To: Development Permit Panel
From: Brian J. Jackson, MCIP
Director of Development
Date: March 4, 2008
File: DP 06-345763
Re: **Application by Interface Architecture Inc. for a Development Permit at
12020 1st Avenue**

**Annotated Excerpt from the Minutes from
The Richmond Heritage Commission
November 16, 2006 Meeting**

2. Development Permit 06-345763
 APPLICANT: Ken Chow
 PROPERTY LOCATION: 12020 1st Avenue

SOUTH ELEVATION
 SCALE: 3/8"=1'-0"

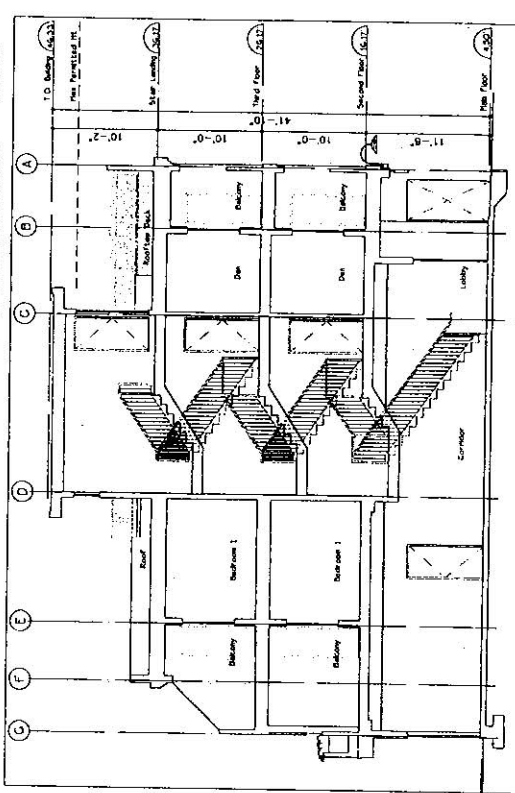
2. **The exposed party wall** – split face concrete block with two colour tones and horizontal banding has been proposed. Due to Building Code issues related to the firewall, the exposed party wall continues to be solid without any openings and requires further design development to provide relief, both horizontal and vertical. This wall is both a hard transition to the important garden next door, and is also highly visible in the Steveston Village. – *The party wall was improved with horizontal siding, a vertical recessed area and horizontal barge boards*

7. Consider further design development to the south facing block wall – ***Incorporated. As discussed earlier, the architect has included measures to improve the appearance of the exposed party wall by breaking down it's appearance into smaller horizontal and vertical components through the use of horizontal Hardi-siding, a vertical recessed area and horizontal barge boards.***

- The party wall to the south will be exposed to views from the street. The architect has included measures to improve the appearance of the exposed party wall by breaking down it's appearance into smaller horizontal and vertical components through the use of horizontal siding, a vertical recessed area and horizontal barge boards;
- The proposed building materials (horizontal wood siding, wood trim, wood frame windows and party wall non-combustible Hardi-plank siding) and colour scheme (muted grey) are consistent with the Official Community Plan (OCP) Guidelines (**Attachment 2**); and
- Surface parking has been located behind the building on-site off the lane with no visual impact to the streetscape.
